A Division of WSE Engineering Services, Ltd
1765 Restoration Rd SW
Rochester, MN 55902
507-282-8206

The following items are conditions for permit issuance and strict compliance is mandatory.

VAULTED END WALL DETAIL

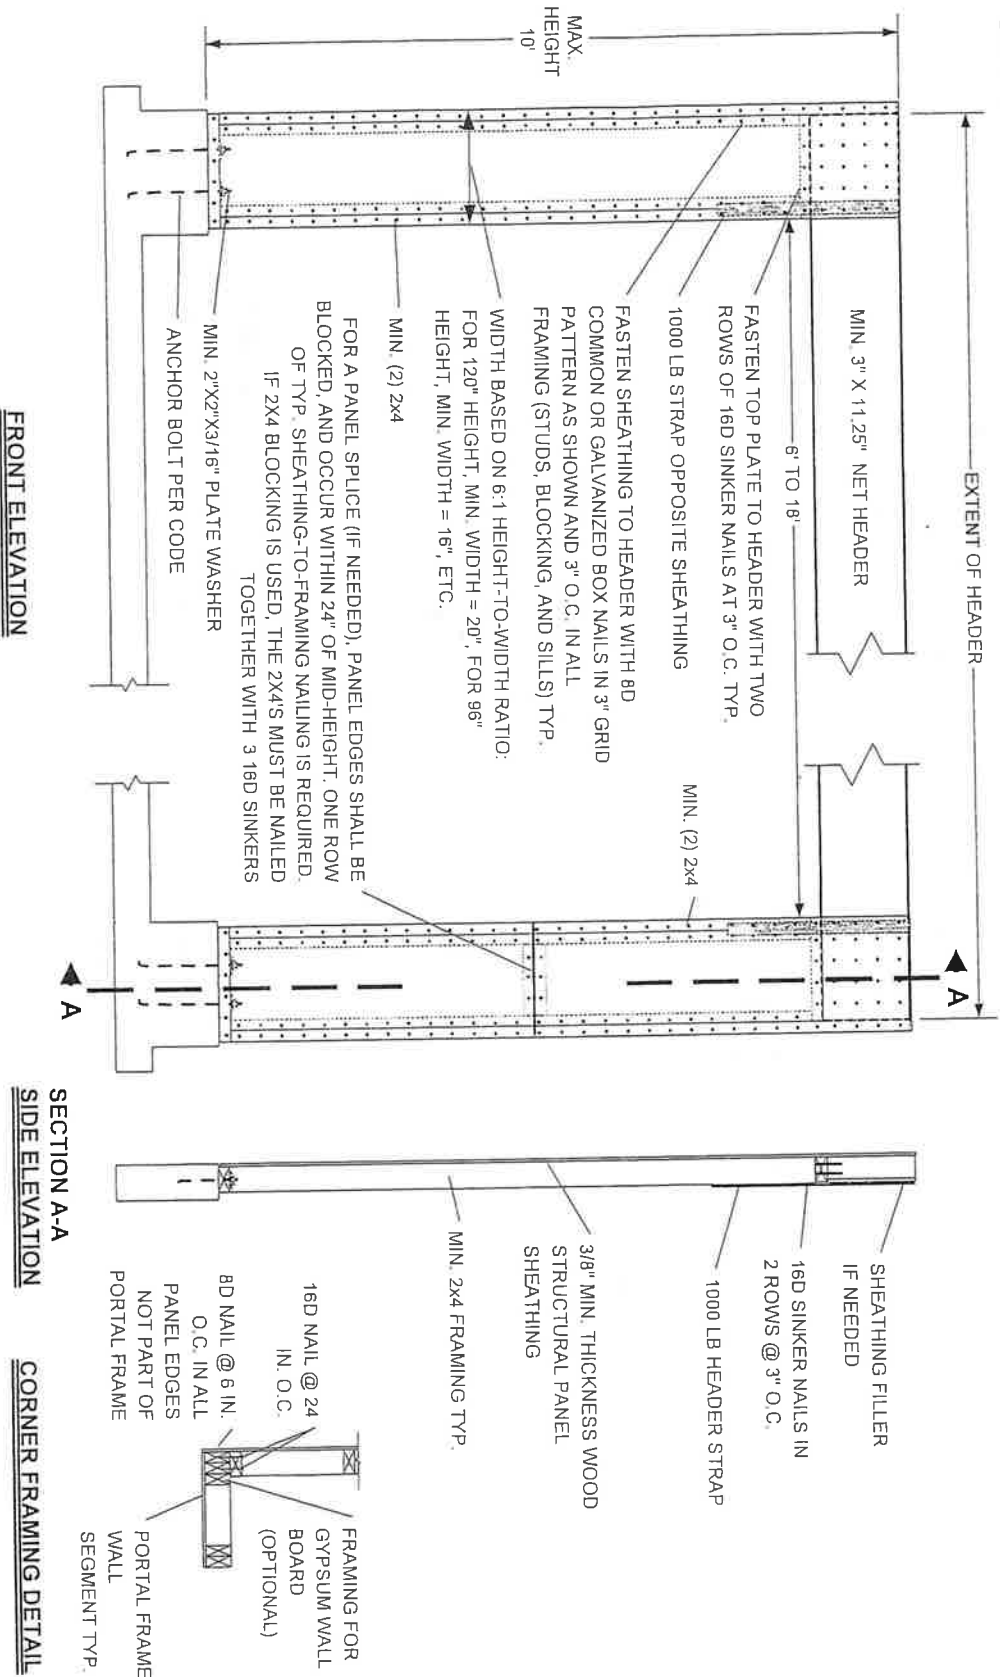
12. Vault walls shall be balloon framed or have King posts installed in them. (see attached)
13. Approved numbers or addresses shall be provided for all new buildings in such a position as to be plainly visible and legible from the street or road fronting the property. MSBC1309/R319.1

FIGURE R602.10.6.4
METHOD CS-PF—CONTINUOUSLY SHEATHED PORTAL FRAME PANEL CONSTRUCTION

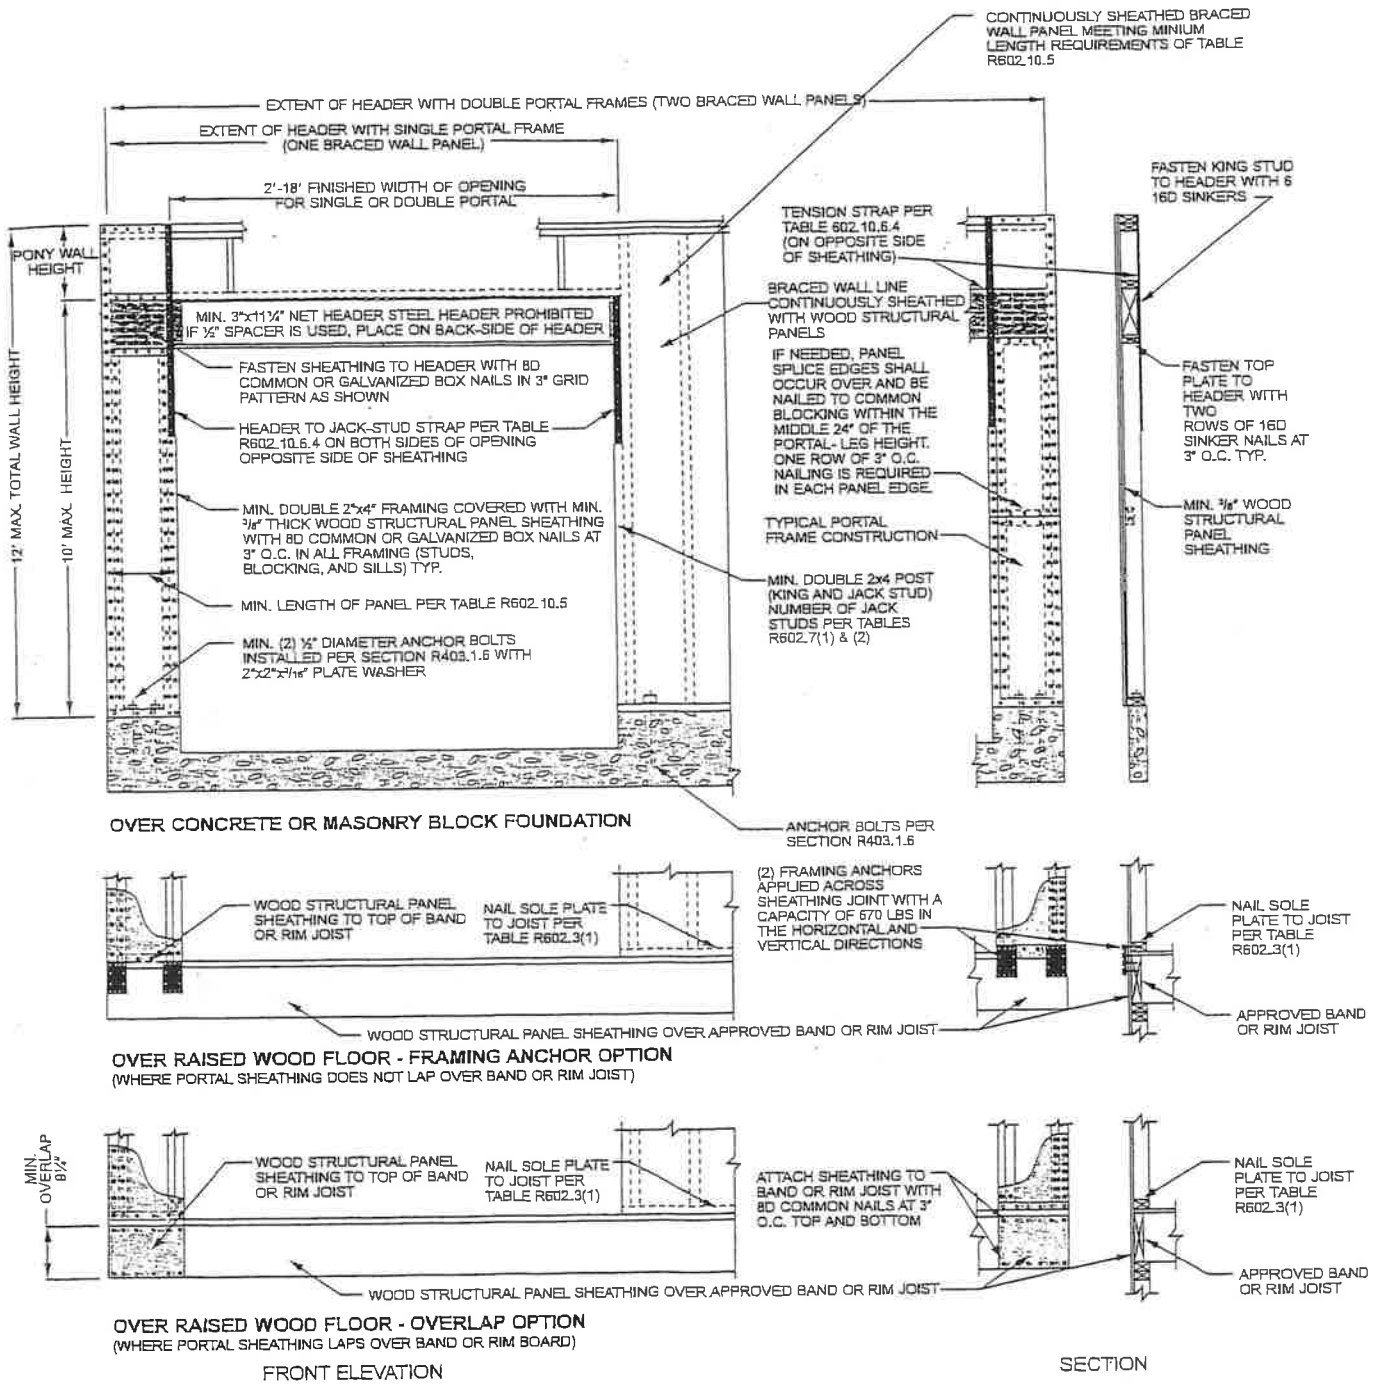
49. Install proper wind bracing. Bracing shall be designed for 115 mph wind load. MSBC1309/R301.2.1
50. Attic ventilation: The total net free ventilation area shall not be less than 1 to 150 of the area of the space ventilated except that the total area is permitted to be reduced to 1 to 300, provided at least 40 percent and not more than 50 percent of the required ventilating area is provided by ventilators located in the upper portion of the space to be ventilated no more than 3 feet below the ridge or highest point, with the balance of required ventilation provided within the bottom third of the attic space. (i.e. eaves) MSBC1309/R806.2
